Re: Tax Map #79.13 – 4 - 45
32 Piney Point Avenue – STOP WORK ORDER

PROPOSED SITE LAYOUT

PROPOSED PINEY POINT AVE
RESIDENCE FOR
MARK FRANZOSO

SP-1.0

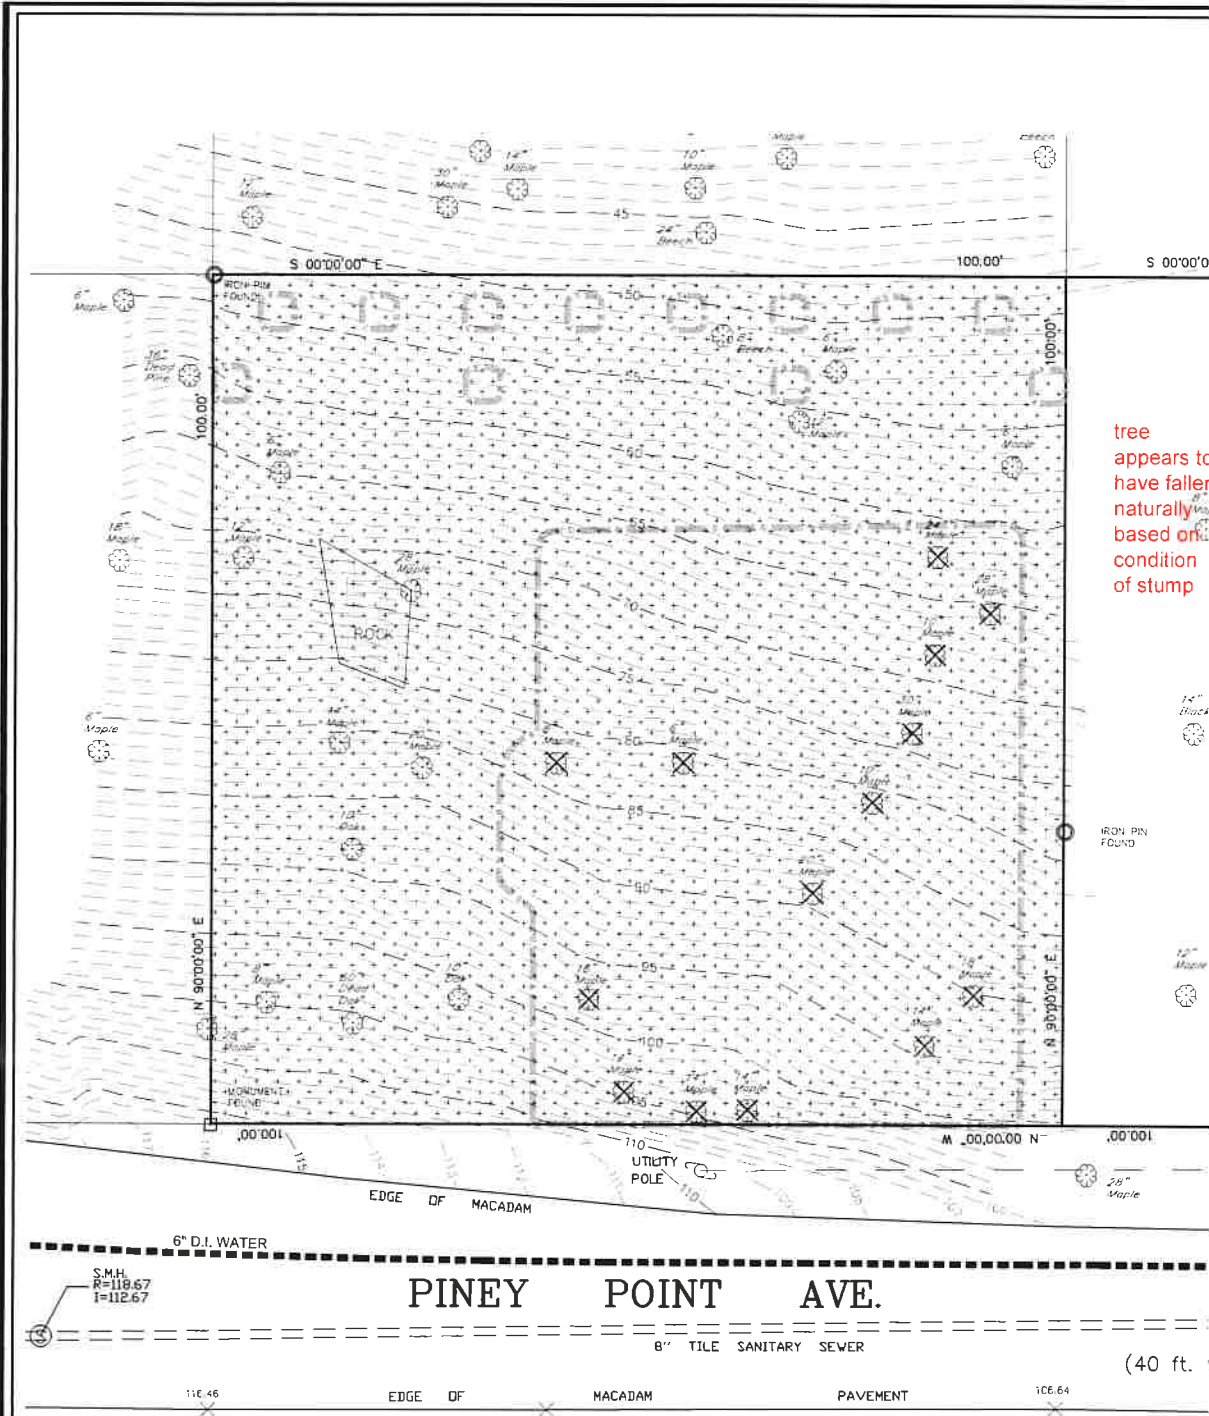
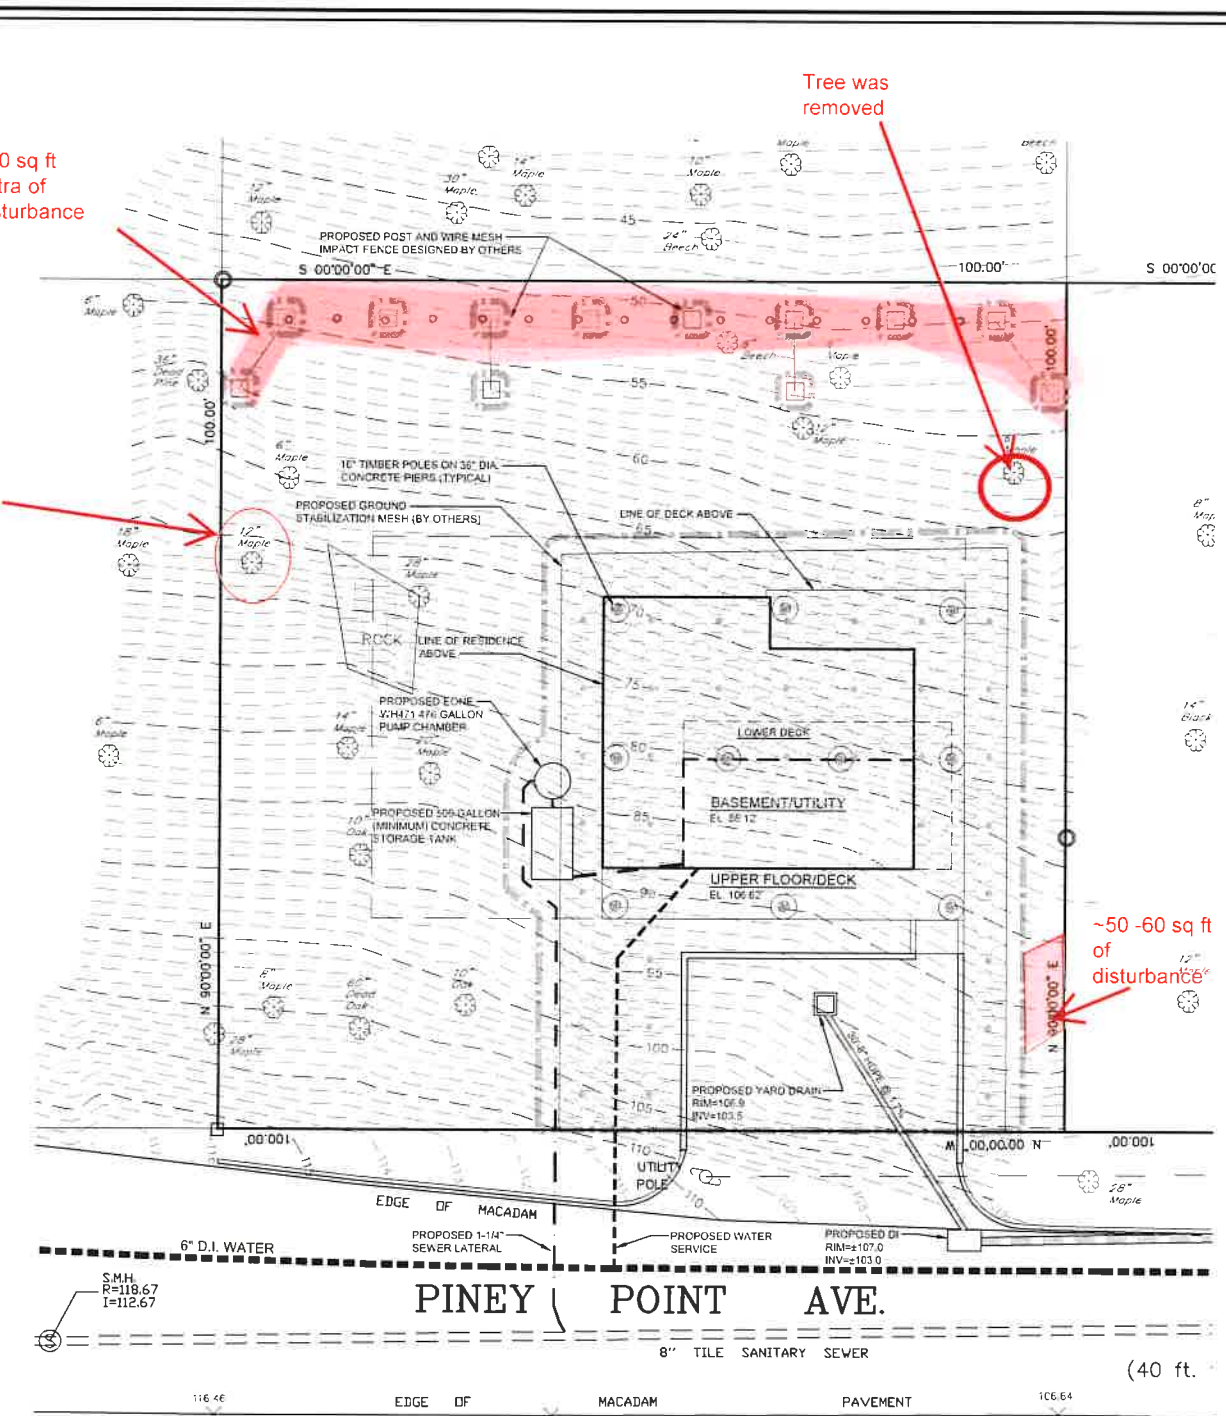
The inspection has shown that one trees on your property to be saved was removed (see attached marked-up plan). The removal of the tree that was to be saved is a violation of the Planning Board Resolution of Minor Site Plan Approval and sections 208-16 of Chapter 208 “Trees” of the Village Code.

The inspection also has shown (see attached marked-up plan) that areas of steep slope outside the approved limit of disturbance were disturbed resulting in the total steep slope disturbance exceeding the threshold for a steep slope permit. The additional steep slope disturbance has resulted in a violation of section 195-3 of Chapter 195 “Steep Slope Protection” of the Village Code.

Based on the above violations a **STOP WORK ORDER** is hereby issued, all work on the above referenced property shall stop until further notice. You are hereby ordered to immediately make application to the Planning Board to amend the Minor Site Plan Approval for the above referenced property to address the above referenced violations. Please also be advised that additional enforcement action may be taken by the Village to address the above referenced violations.
